JAMES A. FITZPATRICK NUCLEAR POWER PLANT

AMENDMENT TO FACILITY OPERATING LICENSE

Amendment No. 78
License No. DPR-59

SAFETY EVALUATION BY THE OFFICE OF NUCLEAR REACTOR REGULATION

FIGURE 6.1-1

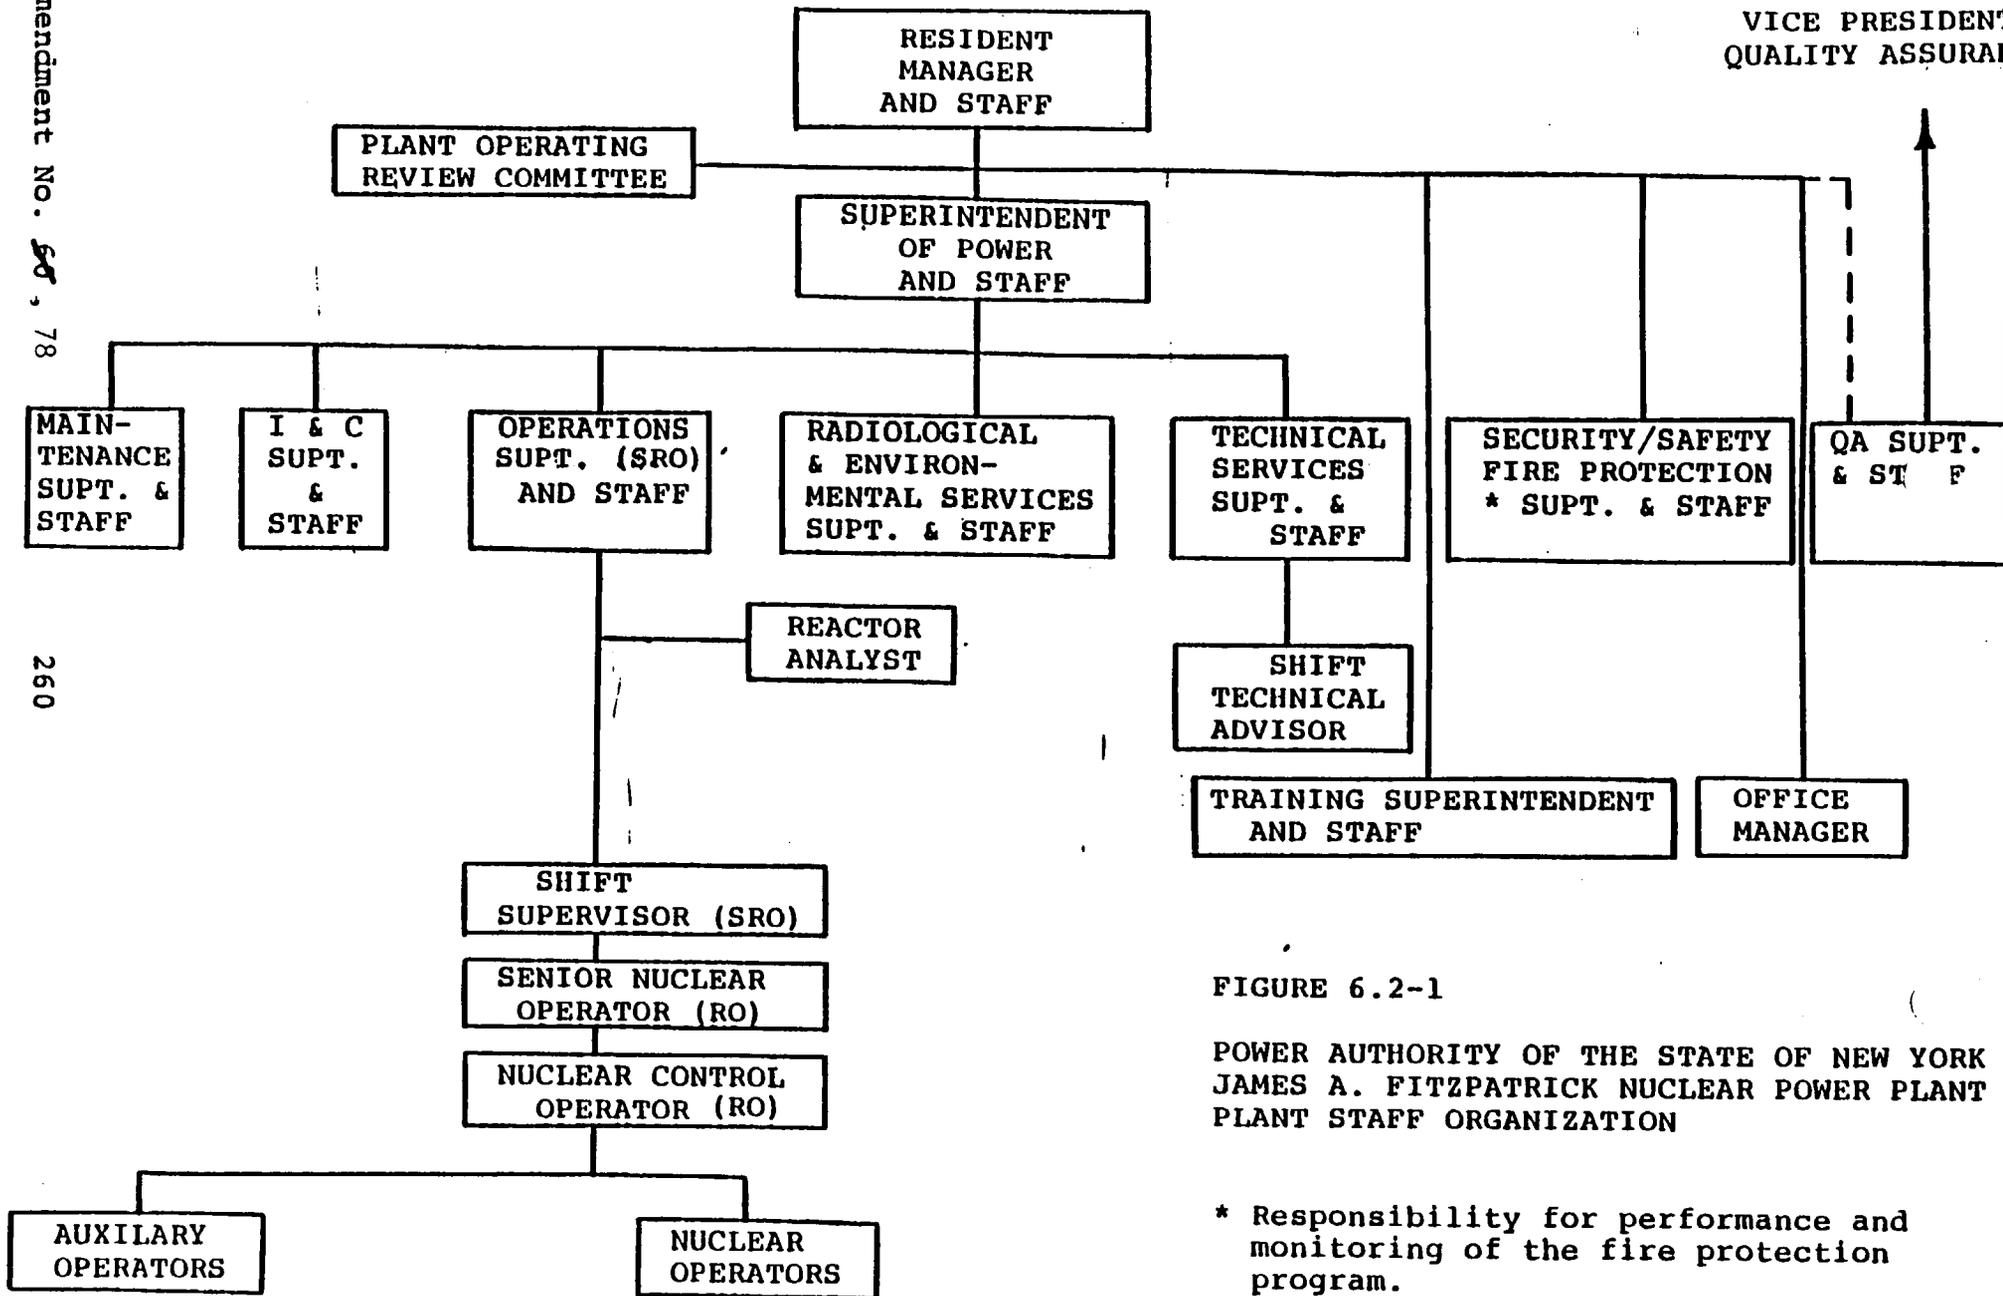
1. The off-site management organization has been revised to add the position of First Executive Vice President and Chief Development Officer and the position of First Executive Vice President and Chief Operations Officer. The title of Executive Vice President Procedures and Performance has been changed to Vice President Quality Assurance and Reliability; and he assumes the duties held previously and, in addition, now performs audits and appraisals of the security program. The title of Senior Vice President Nuclear Generation has been changed to Executive Vice President Nuclear Generation without change of function; and the title of Director of Safety and Fire Protection Procedures and Performance has been changed to Director of Safety and Fire Protection.

Title changes have been made throughout Section 6 of Appendix A and in Figure 5.2-2 of Appendix B to reflect the above reorganization and title changes. The reorganized off-site management organization is shown in revised Figure 6.1-1.

FIGURE 6.2-1

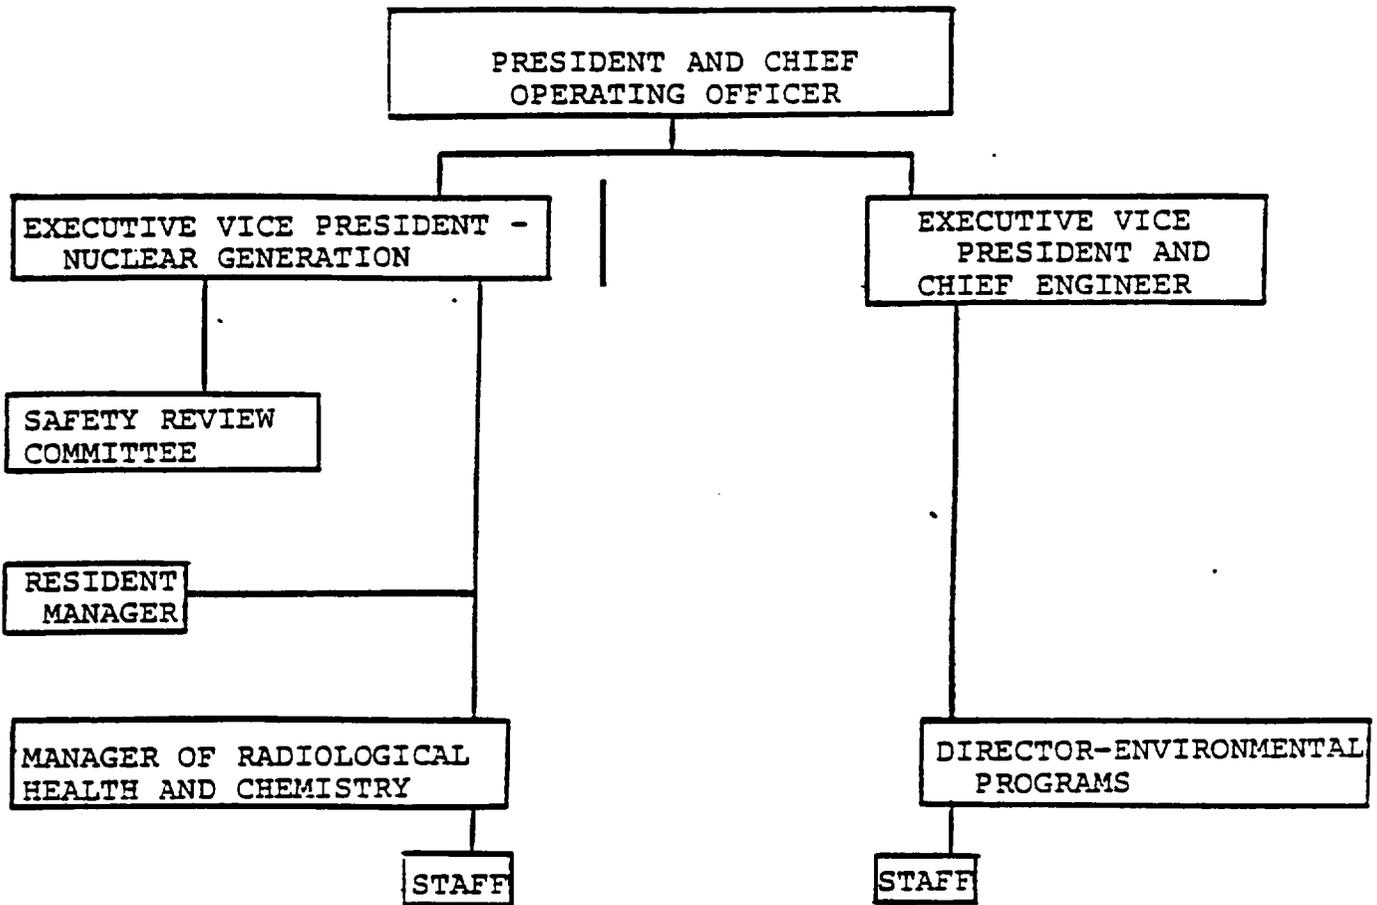
2. The plant staff organization chart has had a footnote added that assigns responsibility for performance and monitoring of the fire protection program. Additionally, the title of Training Coordinator has been changed to reflect the current organization structure. This is shown in Figure 6.2-1.
3. In Section 6.5.2.8, the audit frequencies for emergency preparedness and safeguards contingency plans (Items e and f) have been revised to agree with 10 CFR 50.54(t) and 73.40(d) respectively.
4. The title of the Plant Radiation Protection and Radiochemistry Supervisor has been changed to Radiological and Environmental Services Superintendent in Section 6.11.

* Responsibility for performance and monitoring of the fire protection program.
